INSTRUCTION TO SERVICE

ITS:6364

219 Engine and Transmission

Rework Heat Exchanger Cabin Loop Line and Routing

Figure 2: Cabin Heat Coolant Tube Removal

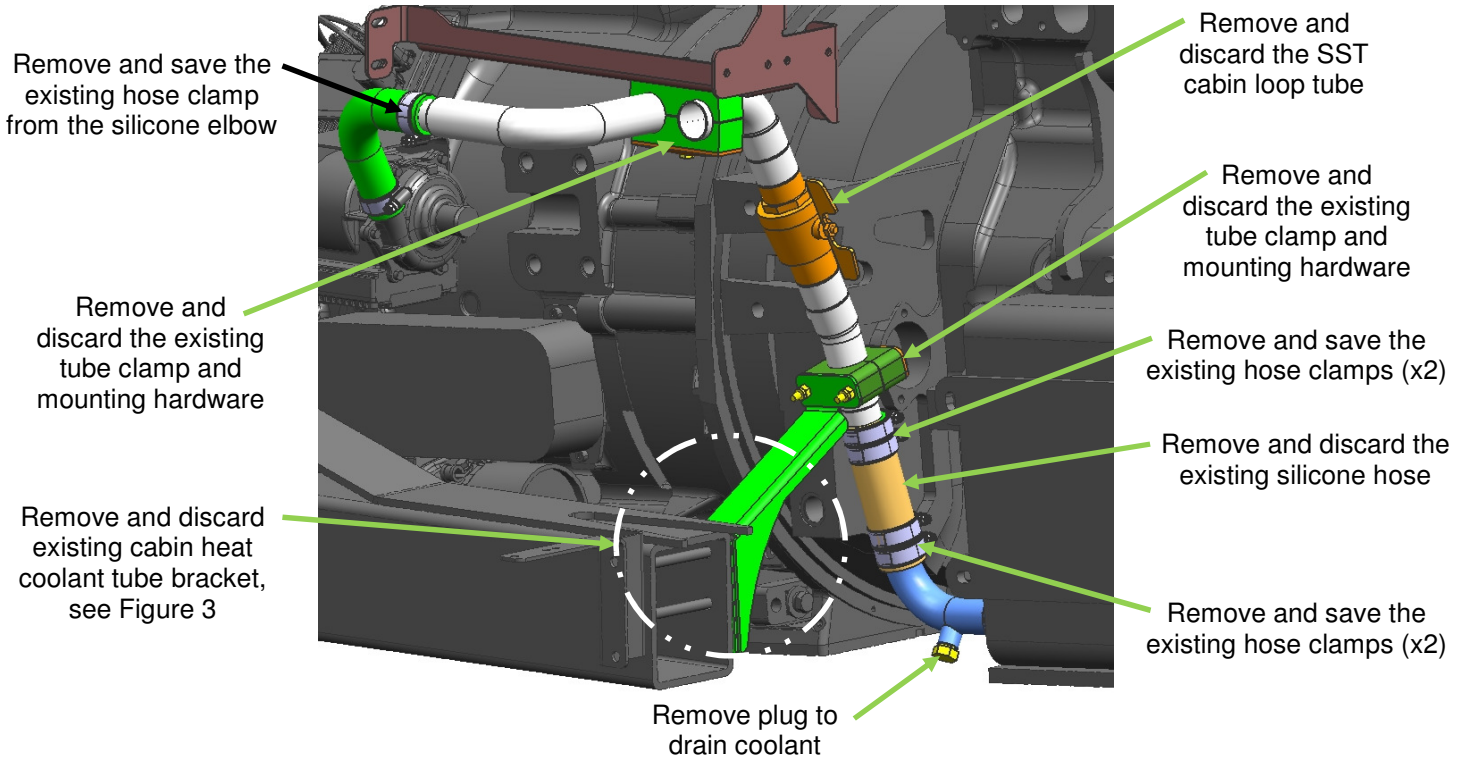
4. Place a suitable container under the heat exchanger cabin loop drain plug. Remove and save the drain plug and drain cabin heat coolant circuit. See Figure 2.

5. If necessary, raise the coach in accordance with the New Flyer Service Manual.
6. Remove and discard the existing tube clamp and mounting hardware supporting the heat exchanger cabin loop SST tube to the degas frame as shown in Figure 2.

7. Remove and discard the existing tube clamp and mounting hardware supporting the heat exchanger cabin loop SST tube to the clamp mounting bracket (bracket may vary in appearance) as shown in Figure 2 and 3.

8. The cabin heat coolant tube support clamp mounting bracket may vary in appearance, remove the bolts from the forward lower radiator tube mounting bracket, remove and discard existing cabin heat coolant tube bracket and re-install the lower radiator tube mounting bracket bolts. Torque bolt (x2) to 40-70 in*lbs dry, see Figures 2 & 3.

9. Remove and save the existing hose clamp from the silicone elbow on the booster pump line to the SST cabin loop tube, see Figure 2.
10. Remove and save the existing hose clamps (x4) from the silicone hose connecting the heat exchanger 90° SST elbow to the SST tube to the booster pump, see Figure 2.

- 11. Remove and discard the existing silicone hose and SST cabin loop tube, see Figure 2.
- 12. Open coolant ports and/or hoses are to be covered with a clean dry lint free cloth.

Figure 4: De-gas Frame Bracket Rework (as shown from the bottom)

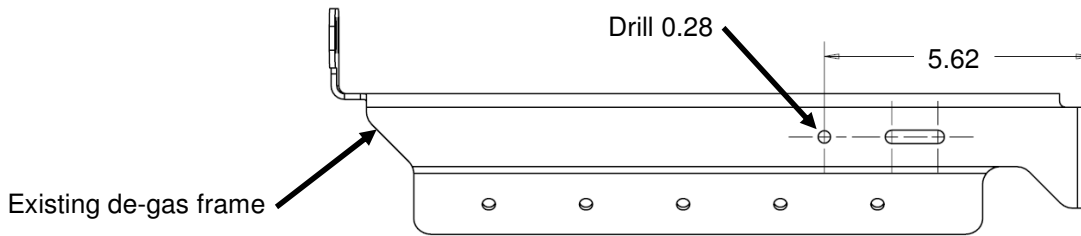
13. Mark and drill a 0.28 Dia clearance hole through the existing de-gas frame as shown in Figure 4.

Figure 5: Tube and Support Bracket Assembly Installation

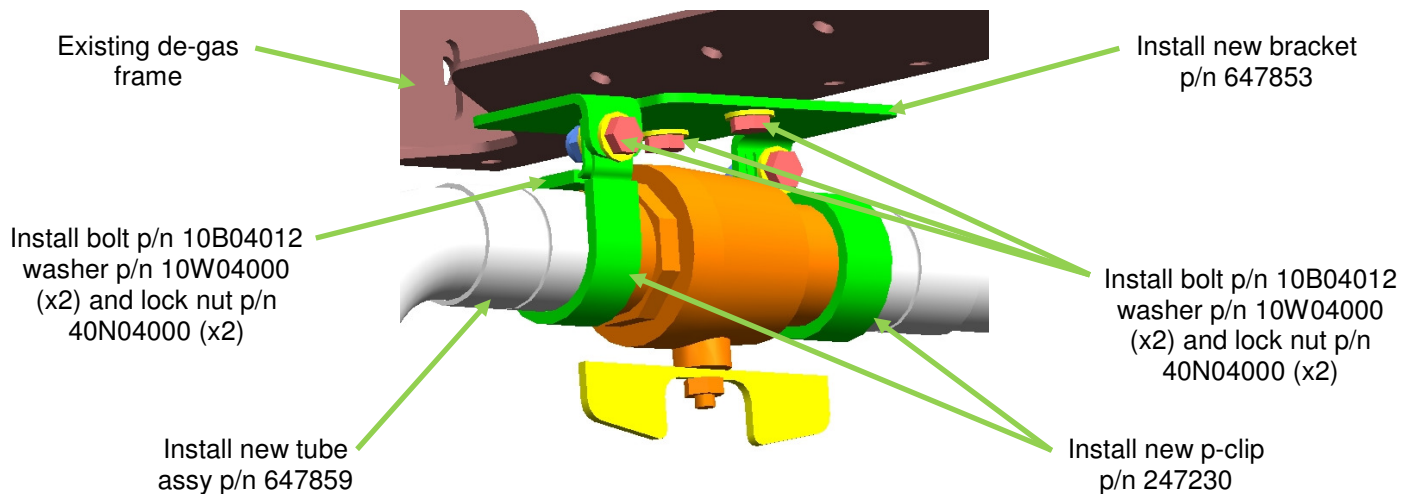
14. Using the newly drilled hole from Step 13 and an existing slot in the de-gas frame install the new tube support bracket p/n 647853 using new bolts p/n 10B04012 (x2), washers p/n 10W04000 (x4) and lock nuts p/n 40N04000 (x2), torque hardware to 12 ft*lbs dry. See Figure 5.
15. Loosely install the new tube assy p/n 647859 to the newly installed bracket from Step 14 using p-clips p/n 247230 (x2), washer p/n 10W04000 (x4) and lock nuts p/n 40N04000 (x2). See Figure 5.
16. When installing the new tube assy to the newly installed bracket, the end to the booster pump is to be loosely installed into the existing silicone elbow at the pump using existing clamp from Step 9. If existing silicone elbow is worn or does not fit correctly to the new tube assy it should be replaced with a new elbow p/n 580701. New elbow it to be trimmed to fit.

Figure 6: Cabin Heat Coolant Tube Installation

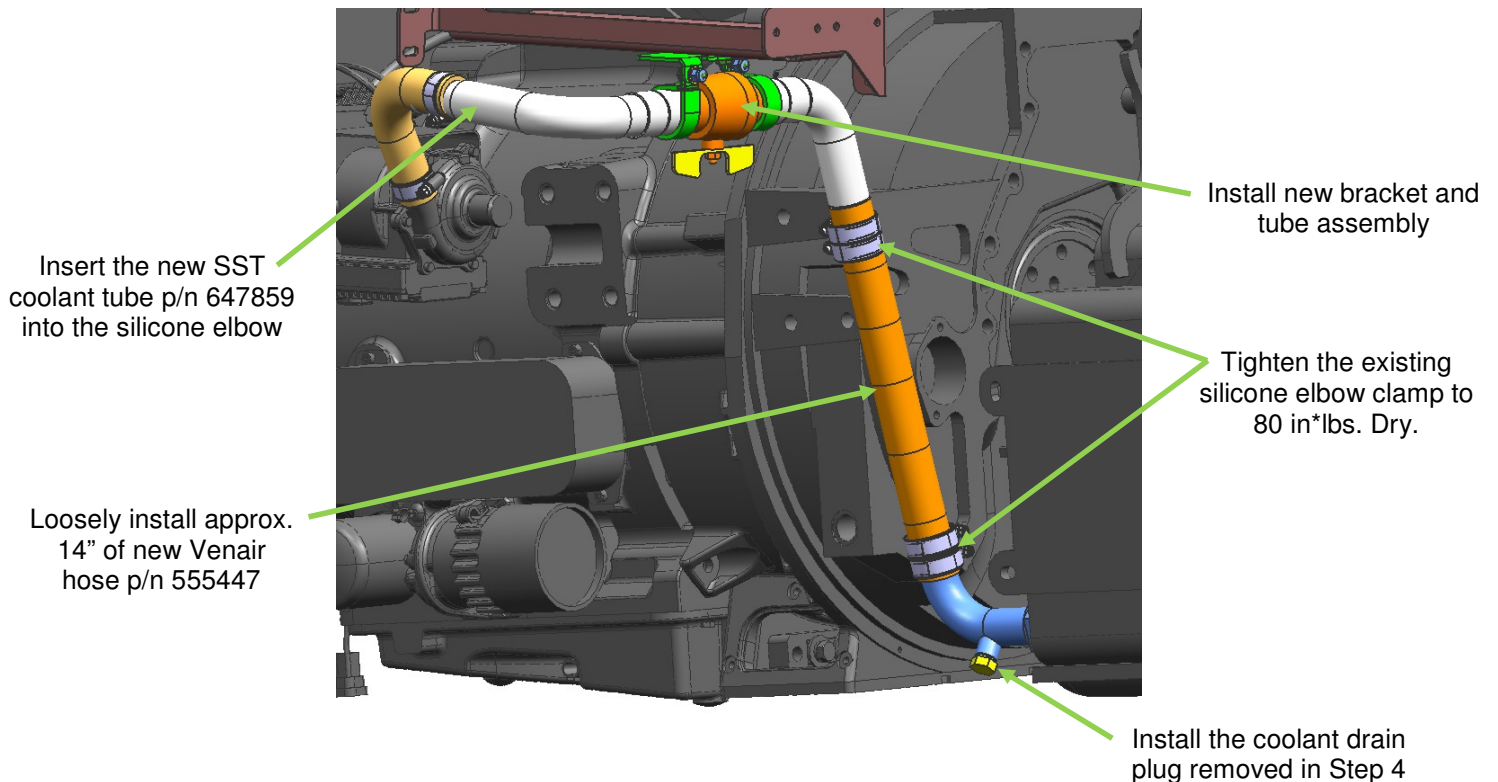
17. Loosely install approx. 14" of new Venair hose p/n 555447 (trim hose to fit) between existing heat exchanger cabin heat SST elbow and newly installed tube from Step 16 using existing hose clamps removed in Step 10, two (2) at each end of the hose.
18. Ensure the hose and tube is free of kinks and routed in a relaxed state and tighten clamps as follows.
 - a. Tighten existing tube assy p-clip hardware installed in Step 13 to 12 ft*lbs dry.
 - b. Tighten the existing silicone elbow clamp from Step 13 to 80 in*lbs. Dry. Tighten at 75 rpm or less, re-torque to 80 in*lbs. at 75 rpm or less after 30 mins.

- c. Tighten the existing silicone hose clamps from Step 15 to 80 in*lbs. Dry. Tighten at 75 rpm or less, re-torque to 80 in*lbs. at 75 rpm or less after 30 mins.
19. Install the coolant drain plug removed in Step 4 as per Step 20.
 20. Fitting installation:
 - a. Inspect the threads to be sure they are not damaged or contain slivers, burrs, dirt or other contaminants.
 - b. Apply thread sealant p/n 8110442 evenly, without air pockets, around the circumference of the thread, leaving the first 1/2 to 1 1/2 threads unpasted and extend to completely cover a minimum of the next three threads. Ensure that orifices remain unblocked. **Note: Threads supplied with Vibra-Seal coating (red dry seal) do not require additional thread sealant.**
 - c. Install the fitting finger tight.
 - d. Apply two full turns past finger-tight.
